Hydro One Networks Inc.

Distribution Rates Application 2018-2022

Power Workers' Union Interrogatories

Figure 31 - ROW Vegetation Demographics

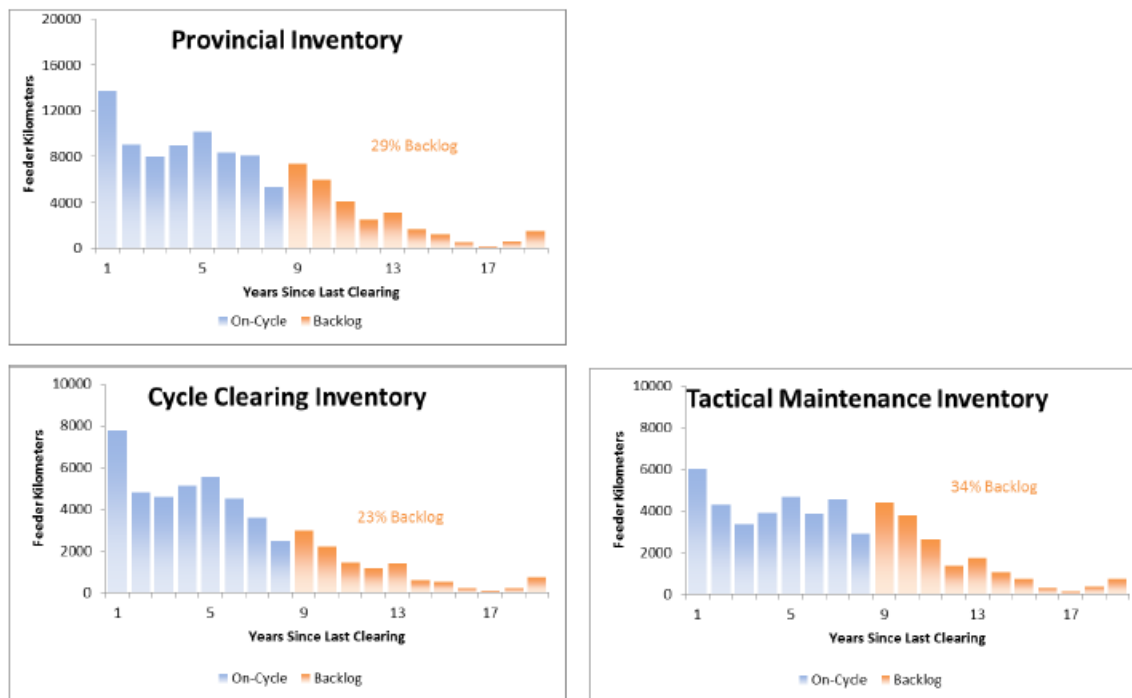
- (a) What are the estimated cycle clearing inventory and tactical maintenance inventory backlogs at the end of the test period?
- (b) What share of Hydro One's ROW is attributable to each of the cycle clearing and tactical maintenance inventories?

Ref (a): Exhibit C1, Tab 2, Schedule 1, Attachment 5, Page 13 of 30

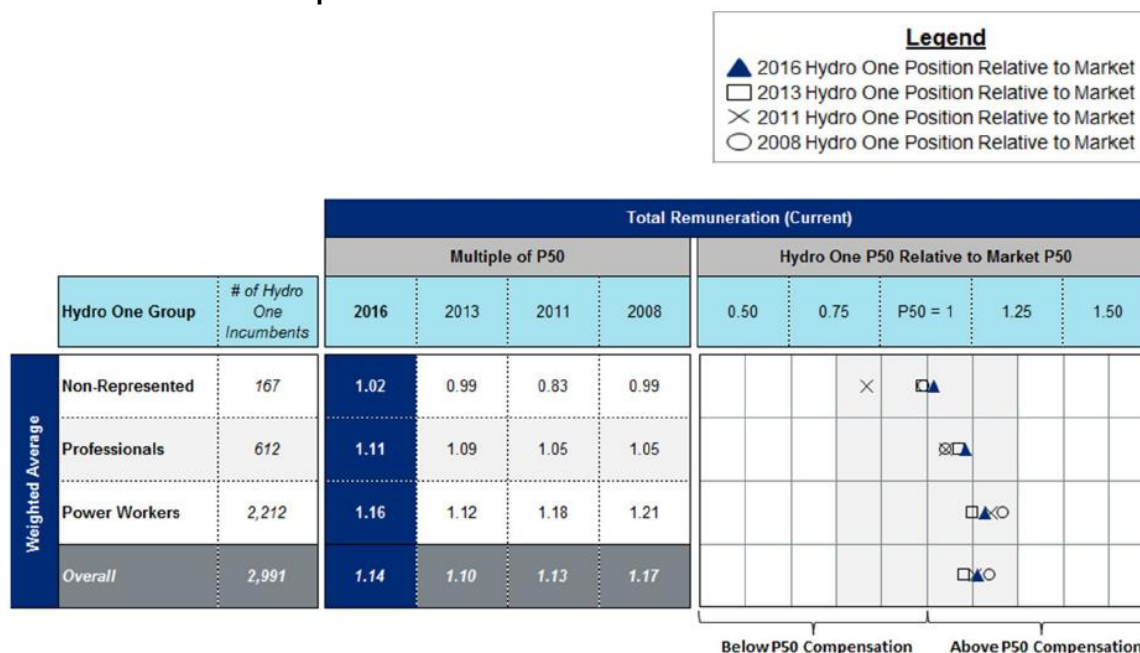
In the 2013 study, Hydro One's overall weighted average was 10% above the market total compensation P50 – a 4% shift from the market median since 2013.

- (a) Please provide the trend in the market median from 2013 to 2016 for both the PWU group and overall.
- (b) Please provide the results for 2013 and 2016 that exclude comparators that are not present in both years.

Ref (a): Exhibit C1, Tab 2, Schedule 1, Attachment 5, Page 14 of 30

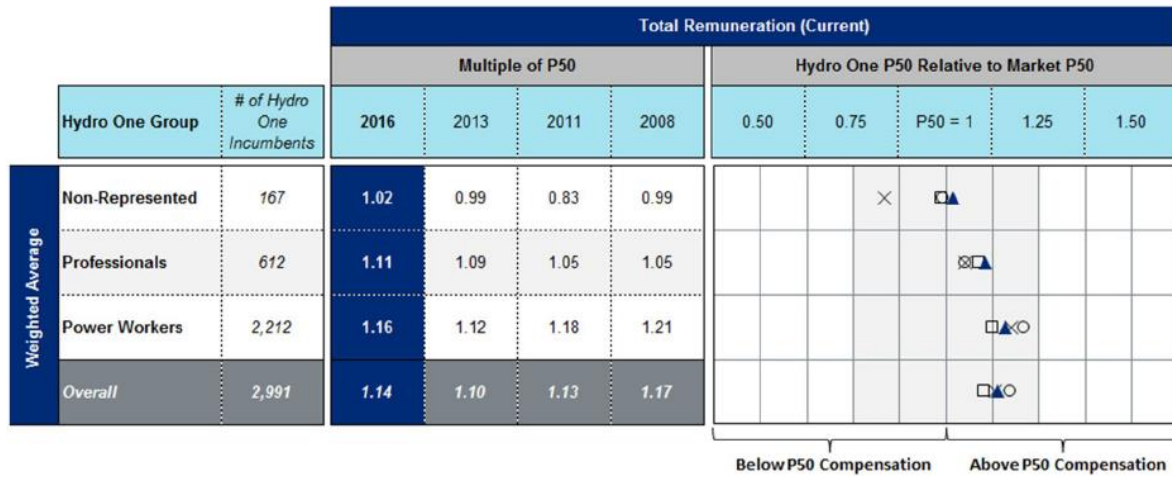
- (a) Why is there no “Future” column for PWU job classifications? If possible, please update Table 7 to include a “Future” column.
- (b) Does the future column for the Society in Table 6 consider the move to the Rule of 85 and adjustment to the final average earnings calculation?

Ref (b): Exhibit C1, Tab 2, Schedule 1, Attachment 5, Page 4 of 30

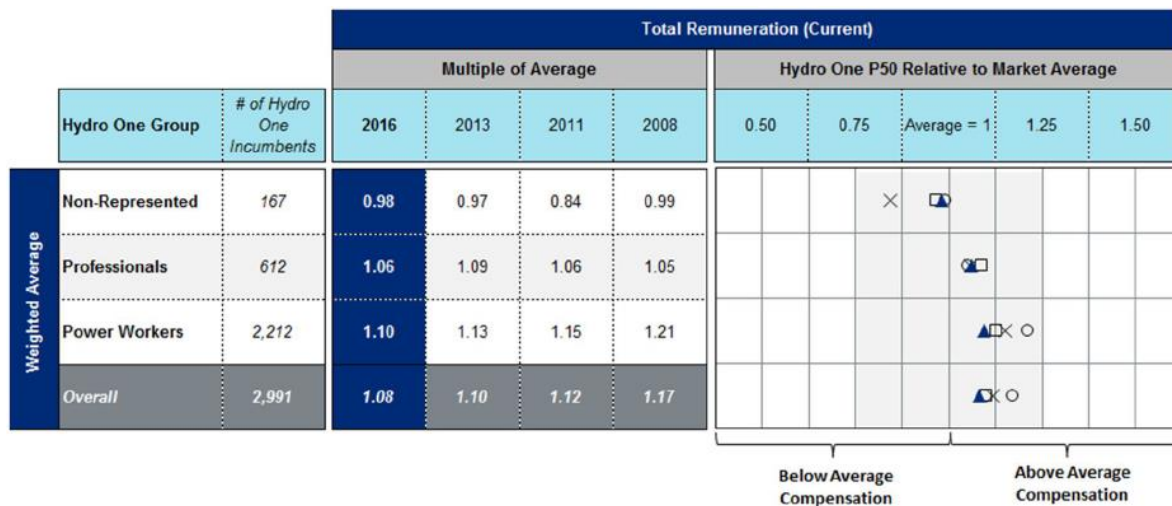
- (a) What drivers, aside from outliers and sample size, can explain the divergence of the market mean and median?
- (b) How can the presence of outliers impact the trend of the market mean?
- Are some peers outliers in terms of compensation trend - rather than outliers in terms of relative market position?

- (c) Hydro One's mean and median relative positions have been similar in Mercer's previous studies and the mean and median trends between studies were consistent. Why is this not the case for the 2016 study?
